Questions for the Circulatory System Devices Advisory Panel

DEN160043

De Novo request for Claret Medical, Inc.’s Sentinel® Cerebral Protection System based on data from the SENTINEL Study

Figure 1: New Lesion Volume by Clinical Stroke Status (Protected Territories)

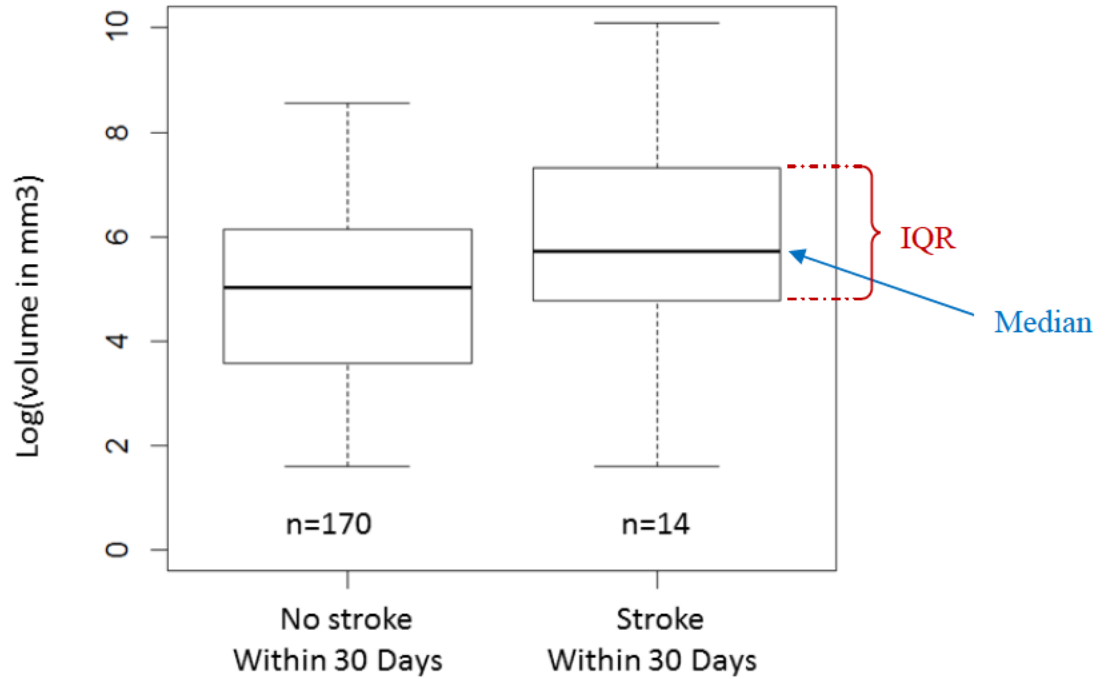
FDA created box plots (see page 3) displaying the observed Day 2-7 DW-MRI total new lesion volume in protected territories only (Figure 1) and in all cerebral territories (Figure 2). The data presented in Figures 1 and 2 consist of Imaging Cohort patients separated by 30 day stroke status. The bold line represents the median and the box length represents the interquartile range (IQR=Q3-Q1). The whiskers represent the spread of the data. More specifically, the whiskers represent the lowest and highest datum still within 1.5 times the IQR. Data available for 14 of the 15 clinical strokes in the Imaging Cohort (5 in the Test Arm; 10 in the Control Arm) show a trend (slightly more pronounced for the protected territory analysis) that patients with stroke had larger lesion volumes than those without stroke, as expected. There is slightly more separation of the two boxes in protected territories (Figure 1), suggesting that new lesion volume in protected territories may be slightly more sensitive to stroke status compared to new lesion volume in all territories. However, new lesion volume measurement does not seem to differentiate patients with clinical stroke, as the ranges for the two groups overlap greatly.

Q2a. Please comment on the appropriateness of DW-MRI as a primary effectiveness endpoint for the SENTINEL study.

Figure 3

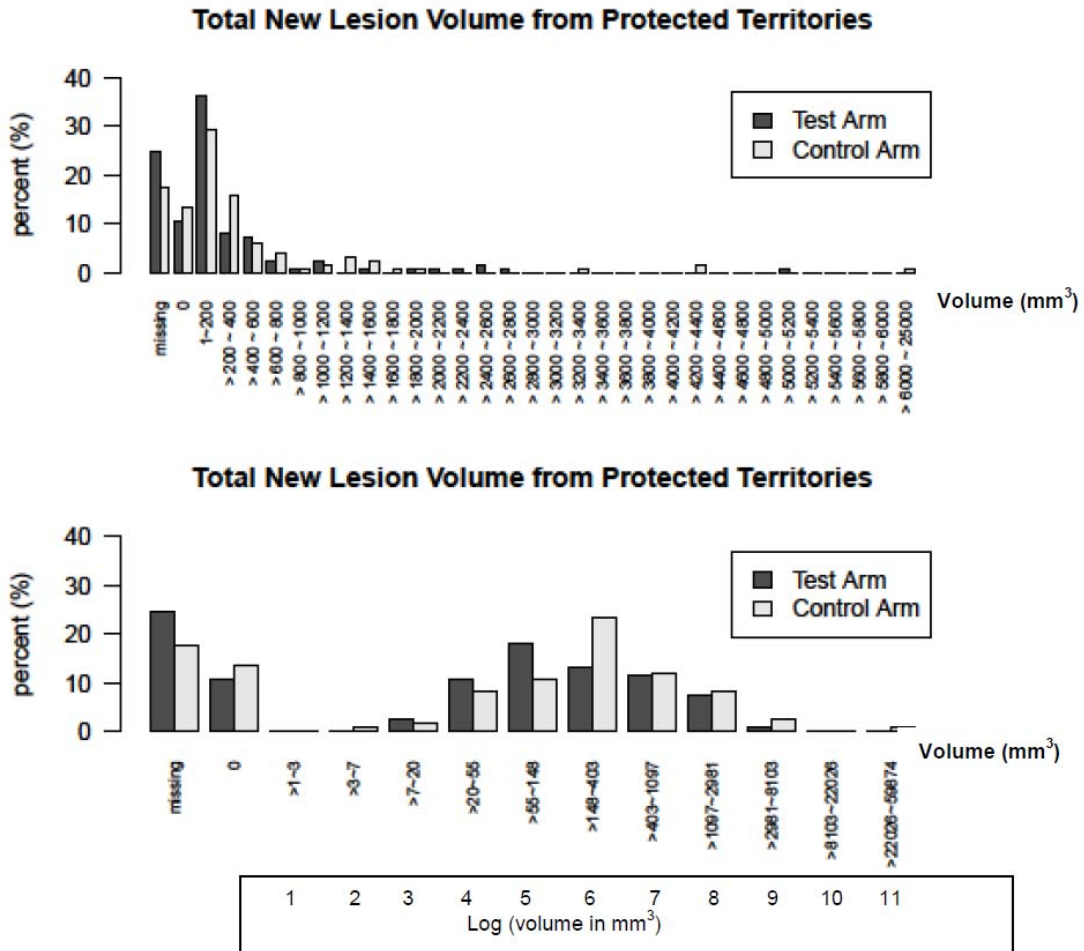
FDA also plotted the frequency distribution of the observed total new lesion volume in protected territories for the Test and the Control Arms (see Figure 3 below). The two plots differ only in how the data are grouped: the top plot uses equal width intervals (in an increment of 200 mm³), while the bottom plot uses unequal width intervals but equal width intervals under log scale. The distribution of the observed total new lesion volume for the Test Arm shows a small shift to the left, suggesting a slightly lower total volume in the Test Arm as the results based on medians indicated. Note that “missing” is the percent of subjects with missing lesion volume measurements (Test: (121-91)/121 = 24.8%; Control: (119-98)/119 =17.6%) and “0” indicates the percentage of subjects with no new lesion volume (or new lesion volumes below a detectable level).

Q3a. Please discuss whether the reduction in new lesion volume in protected territories observed in the Test Arm is clinically meaningful.

Figure 4

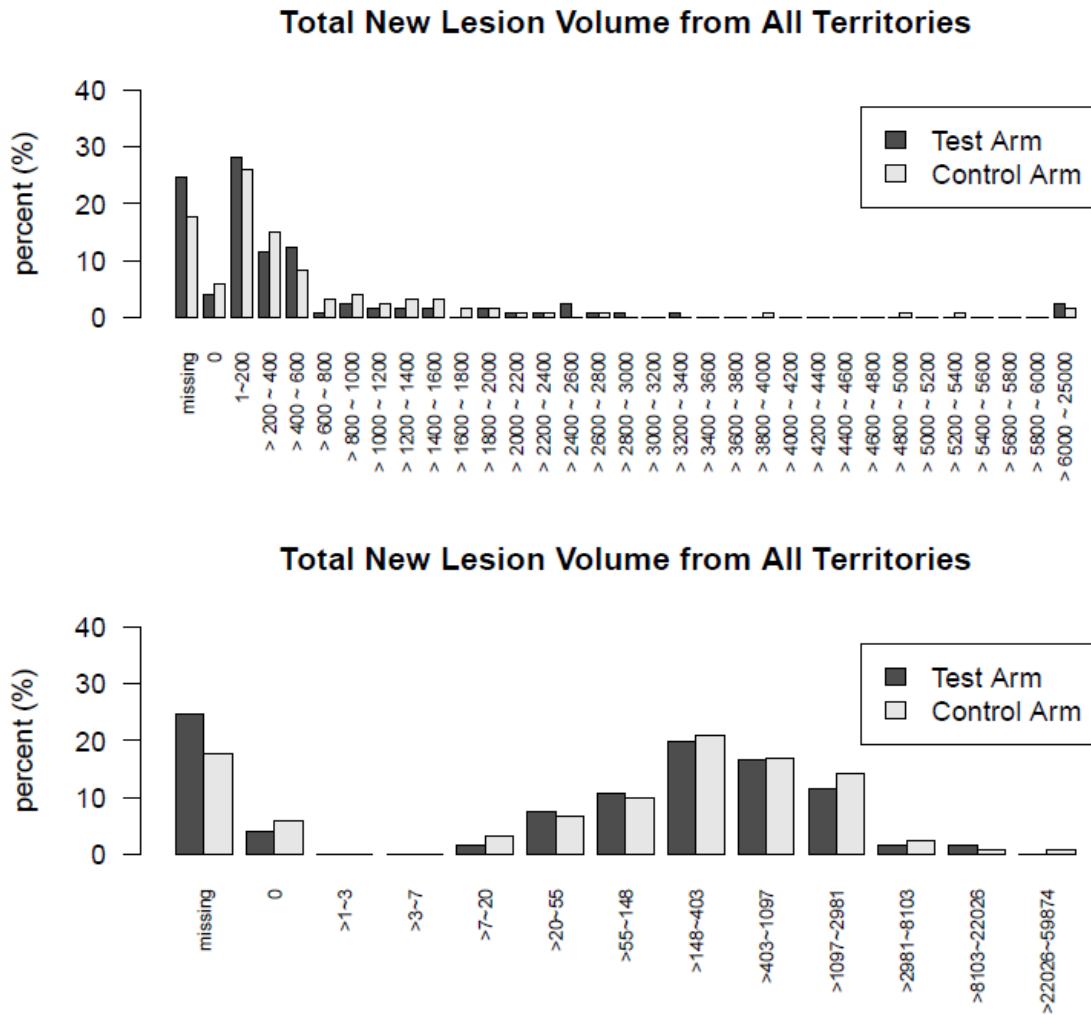
Similarly, FDA plotted the frequency distribution of the observed total new lesion volume in all cerebral territories for the Test and the Control Arms (see Figure 4 below).

Q3b. Please discuss the clinical appropriateness of reporting the effectiveness outcomes for protected territories versus all territories in the labeling, if the De Novo request were to be granted.

Figure 6: Change in Neurocognitive Test Battery Z-Scores from Baseline to 30 Days

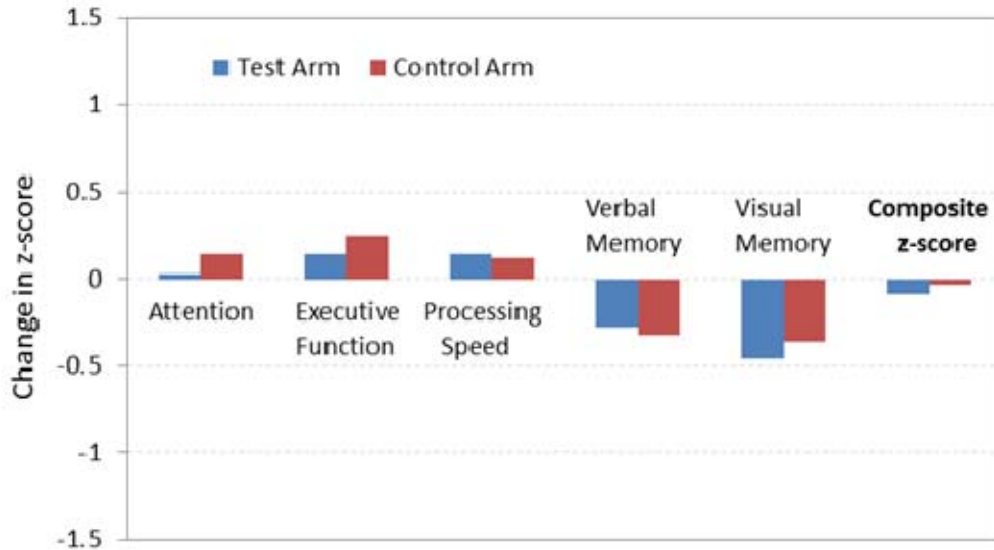
These assessments did not show any discernable difference between patients with protection with the Sentinel System and those patients without protection. However, in a post-hoc analysis, the sponsor showed a secondary correlation of decrease in neurocognitive testing z-score with increase in lesion volume and number.

Q5. Please comment on the clinical significance of the neurocognitive outcomes.
